September 5, 2023

**Subject: Approved - Lake Auburn Source Water Protection Area Boundary Re-Delineation,
Gracelawn Parcel area, Auburn, ME**

CDM Smith Report, Figure 1:

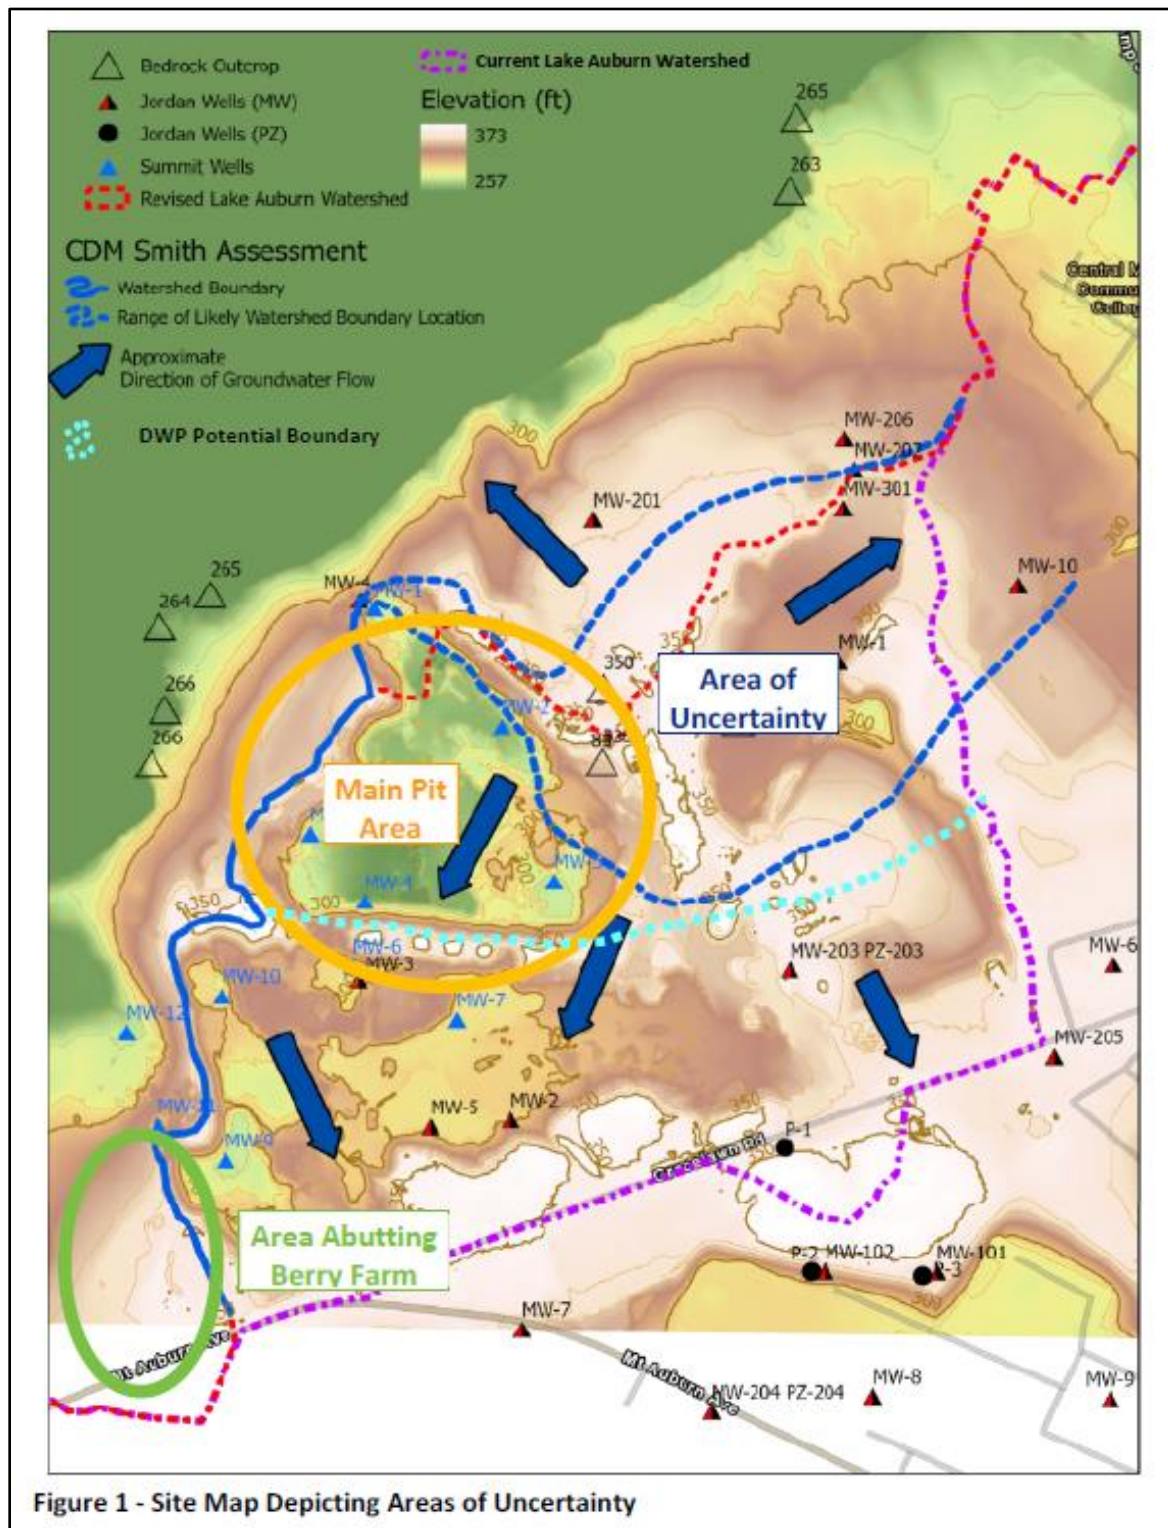
The DWP agrees with the CDM Smith finding that the “DWP Potential Boundary” on Figure 1 below is a conservative boundary that can be established with available data. The DWP will not challenge this boundary, based on our current understanding of local hydrogeology.

The DWP also agrees that further investigation would be needed to establish a boundary closer to Lake Auburn. In addition to the CDM Smith Report’s recommendations that additional data be added to further refine the boundary location, the DWP recommends the following additional action items:
